# VEHICLE RECALL

G-05514-R1  
December 2005

**SUBJECT: SAFETY RECALL (U.S., EXPORT)  
BATTERY CABLES on 9000 models built 4/1/2002  
thru 6/15/2005**

## **REVISION DESCRIPTION**

**Figure 1 – Gap Measurement**

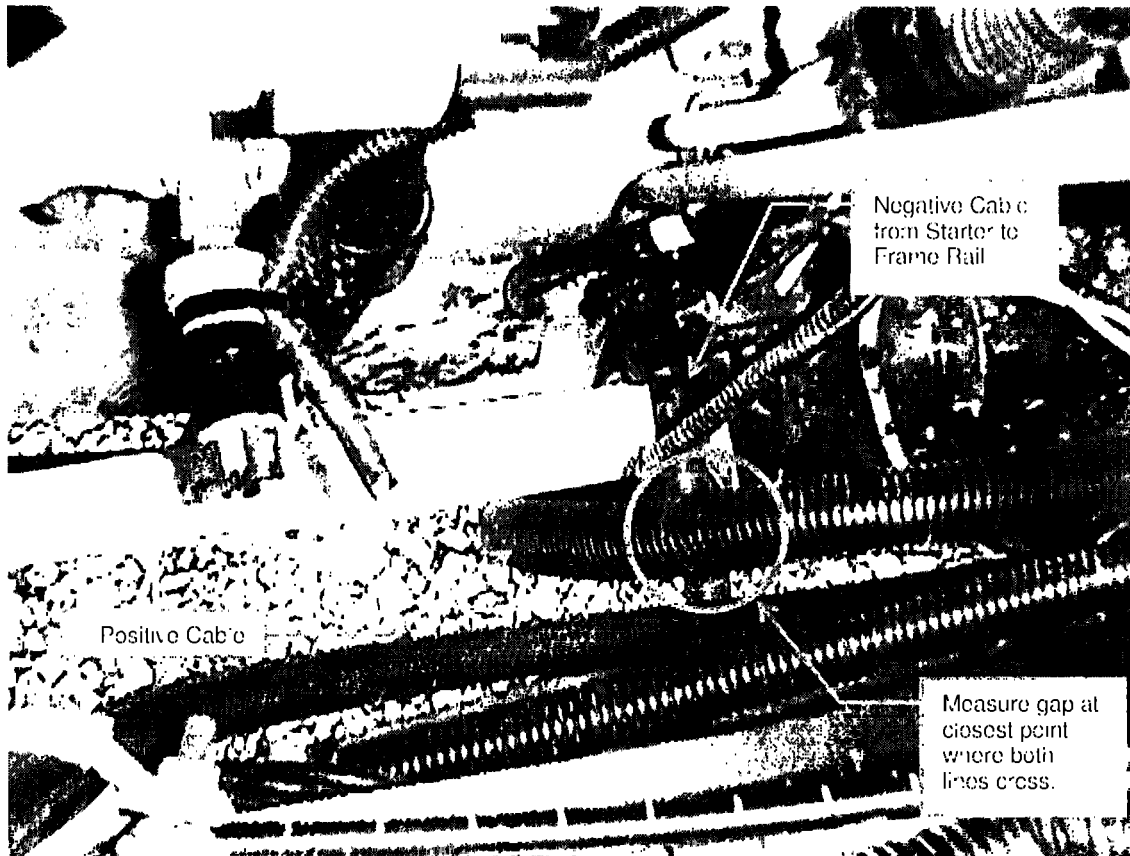
1. For Cummins ISM w/ fuel filter, do not perform the gap measurement, skip to the **BATTERY CABLE INSPECTION PROCEDURE**.
2. For Caterpillar, Cummins ISX, and Cummins ISM w/o fuel filter, perform the following gap measurement.
3. Measure the smallest gap between the positive cable's conduit and the closest point to the negative cable bolted to the frame rail. See Figure 1.

4. If the smallest gap is less than 1.5 inches (38mm) continue on to **BATTERY CABLE INSPECTION PROCEDURE.**

5. If the smallest gap is 1.5 inches (38mm) or LARGER, then no further inspection or saddle clamp installation is necessary – **END SERVICE PROCEDURE.**

**Figure 4 – Engine Removed for Clarity**

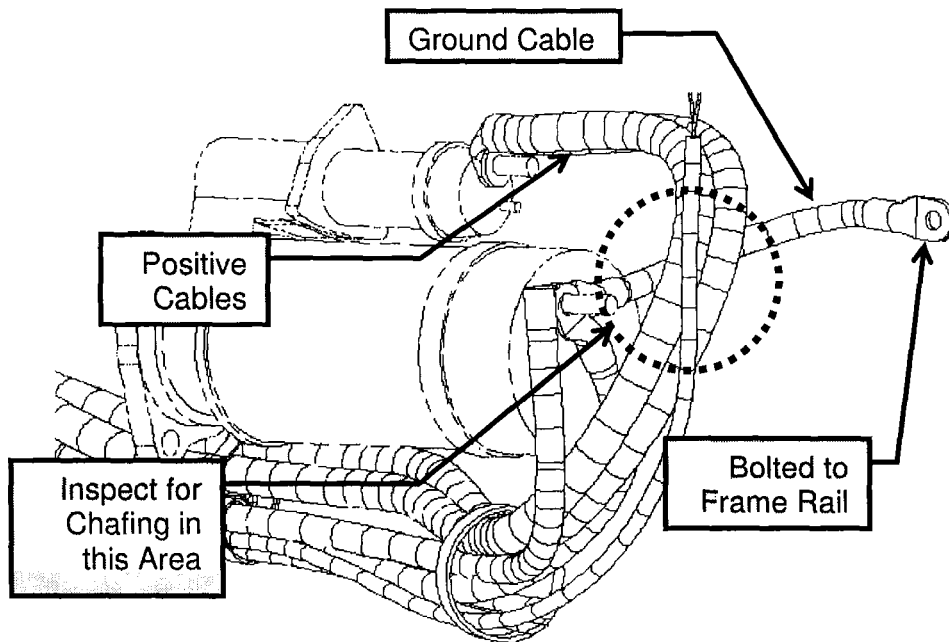
6. For ALL suspect vehicles, if the gap measured above is less than 1.5 inches (38mm), perform the following battery cable inspection procedure.
7. Inspect positive (red) battery cables, conduit and ground cable (black) in areas indicated below:

8. If ANY indication of chafing or rubbing is evident, replace any affected cables and continue to step 11.
9. If there is NO indication of chafing or rubbing, continue on to **SADDLE CLAMP INSTALLATION**.

**Figure 5 – w/o fuel filter**

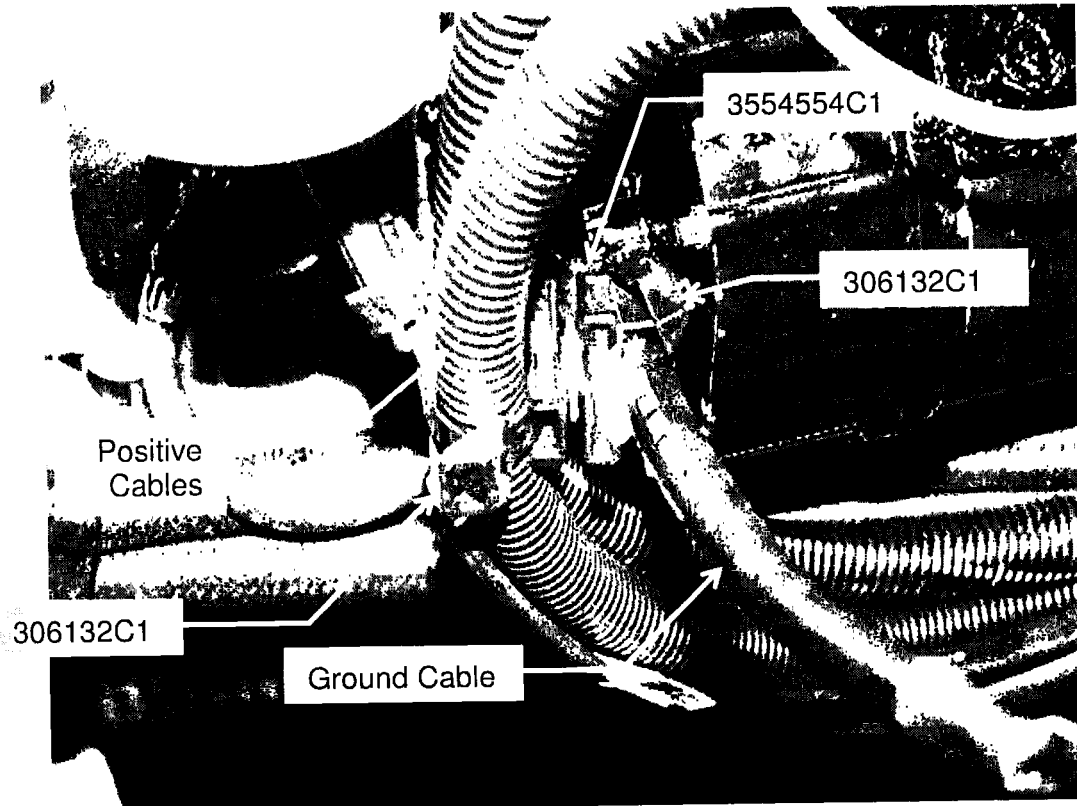
10. For Caterpillar, Cummins ISX, and Cummins ISM (w/o fuel filter), see Figure 5.

11. Install saddle clamp and strap-locks as indicated below:

Figure 6 – Cummins ISM w/Fuel Filter

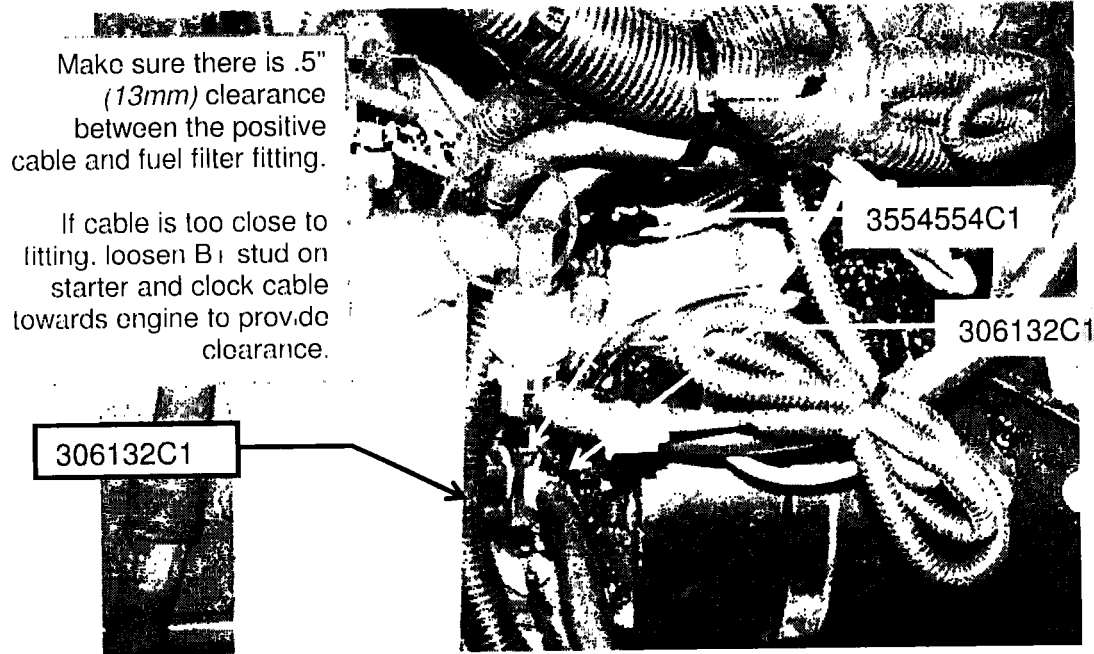
12. For Cummins ISM engines with fuel filter please see Figure 6.

13. Install saddle clamp and strap locks as indicated below.

14. Re-route battery cables between the fuel filter and engine block.

**NOTE: Ensure battery cables do not chafe on fuel filter assembly or fittings.**

Figure 8 – Correct CAT engine block ground cable routing.

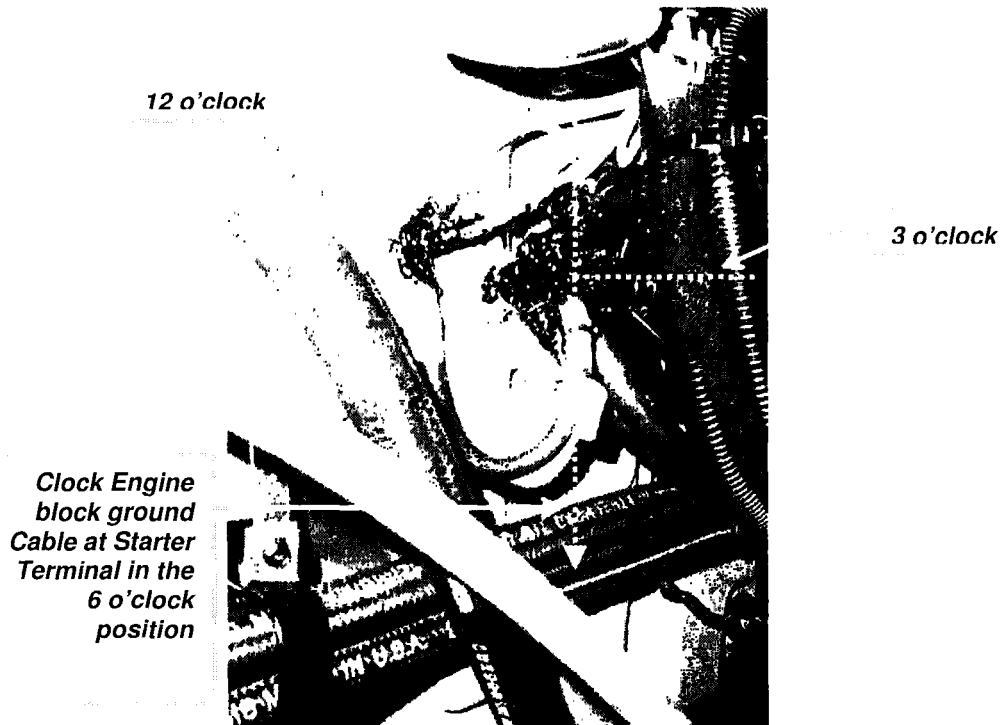
- After performing this recall on vehicles with Caterpillar engines, please inspect the routing of the ENGINE BLOCK ground cable.

**TO PREVENT CHAFING OF THE POSITIVE CABLES AGAINST THE ENGINE BLOCK GROUND CABLE (SEE FIGURE 7), PLEASE ENSURE ENGINE BLOCK GROUND CABLE IS CLOCKED IN THE DOWNWARD (6 O'CLOCK) POSITION, SEE FIGURE 8.**

- If necessary, rotate and tighten the new ground cable on the starter terminal so it is straight down (6 o'clock position) and *not* contacting the starter positive cables, see figure 8.
